Access Compliance Report

Public Rights-of-Way

Intersection ID: 53147	Main Street: ACHIEVEMENT_LN	Cross Street: NEW_RENAISSANCE_WY	Location: NW
ADA ID: 668B381B9C32	Ramp Type: Perp	Initial Pass/Fail: Fail	Overall Compliance: No
		Severity Score: 25

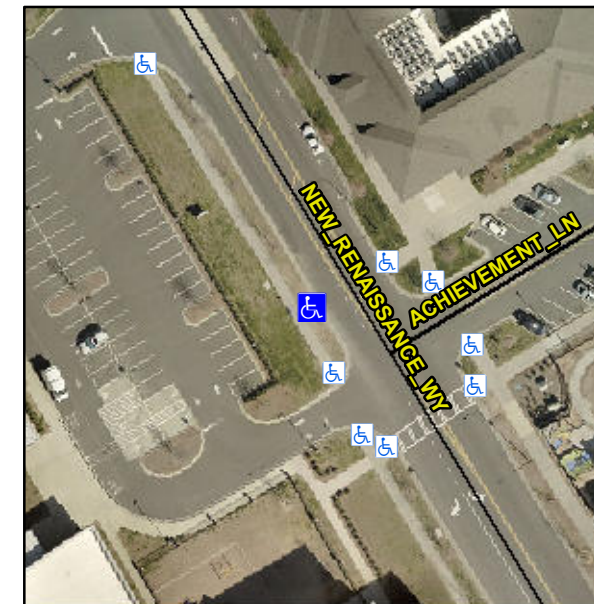
R304.2.2, R304.5.3

Compliance	Description	Data	Compliance	Description	Data
N/A	Ramp Length (in)	83.0	No	Ramp Slope (%)	9.7
Yes	Ramp Width (in)	70.0	No	Ramp XSlope (%)	5.1
N/A	Flare Type LT	N/A	N/A	Flare Type RT	N/A
N/A	Flare Slope LT (%)	N/A	N/A	Flare Slope RT (%)	N/A
N/A	Flare Traversable LT?	N/A	N/A	Flare Traversable RT?	N/A
N/A	Landing Length (in)	N/A	N/A	DWS Provided?	N/A
N/A	Landing Width (in)	N/A	N/A	DWS Contrast?	N/A
N/A	Landing Slope (%)	N/A	N/A	DWS Length (in)	N/A
N/A	Landing X Slope (%)	N/A	N/A	DWS Full Width?	N/A
N/A	Landing Curb? (Y/N)	N/A	N/A	DWS Offset (in)	N/A
N/A	Shared Landing?	N/A			
N/A	Gutter Ponding?	N/A	N/A	Gutter Slope (%)	N/A
N/A	Gutter Lip Ht (in)	N/A	N/A	Gutter X Slope (%)	N/A
N/A	Painted X Walk1?	No	N/A	Painted X Walk2?	N/A
	X Walk 1 Direction	To E		X Walk 2 Direction	N/A
N/A	X Walk 1 Width (in)	N/A	N/A	X Walk 2 Width (in)	N/A
	X Walk 1 Slope (%)	3.3		X Walk 2 Slope (%)	N/A
	X Walk 1 X Slope (%)	2.4		X Walk 2 X Slope (%)	N/A

Remove & Replace Entire Ramp.
